Attachment to AEP:NRC:1018A

Proposed Revised Technical Specification Changes

POWER DISTRIBUTION LIMITS

FIGURE 3.2-4
Exposure Dependent F_Q^L Limit, $F_Q^L(E_L)$, and Normalized Limit $T(E_L)$ as a function of Peak Pellet Burnup for Exxon Nuclear Company Fuel

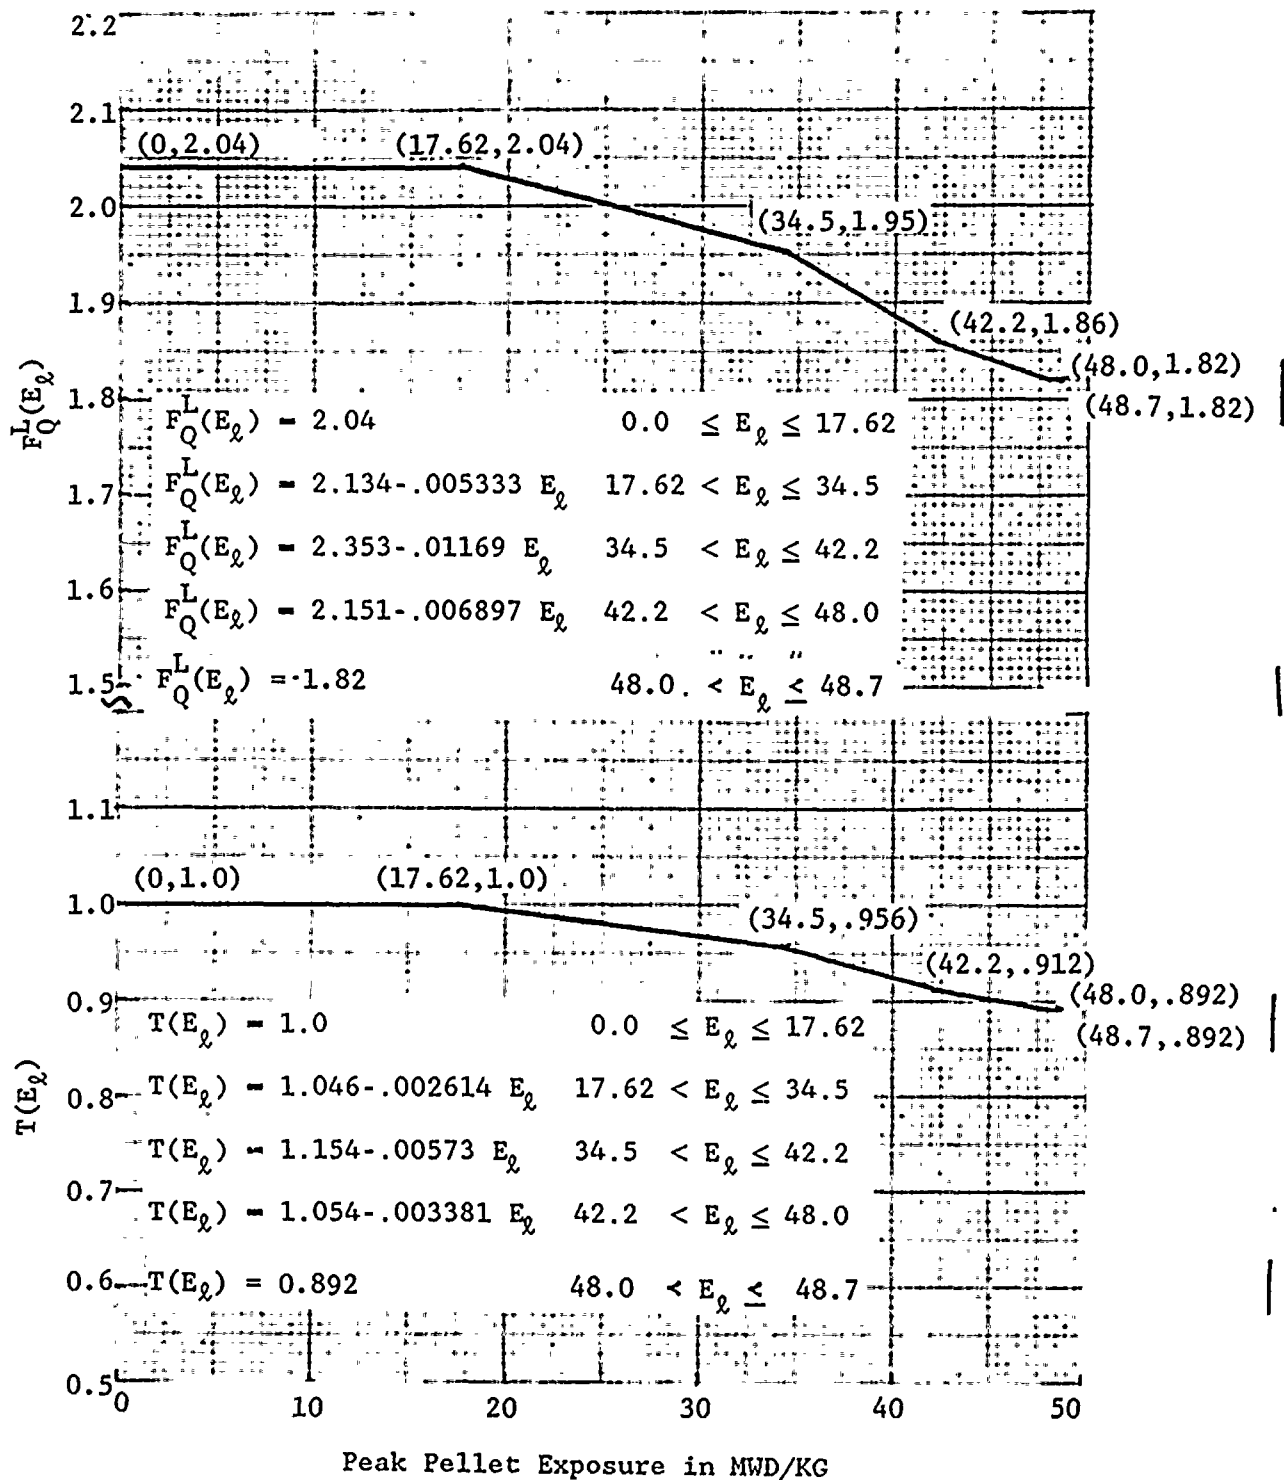
$V(Z)$ is a cycle dependent function and is provided in the Peaking Factor Limit Report. $K(Z)$ is defined in Figure 3.2-2 for Exxon Nuclear Company fuel and in Figure 3.2-3 for Westinghouse fuel. $T(E_\ell)$ is defined in Figures 3.2-4 and 3.2-5. $E_p(Z)$ is an uncertainty factor to account for the reduction in the $F_Q^L(E_\ell)$ curve due to accumulation of exposure prior to the next flux map.
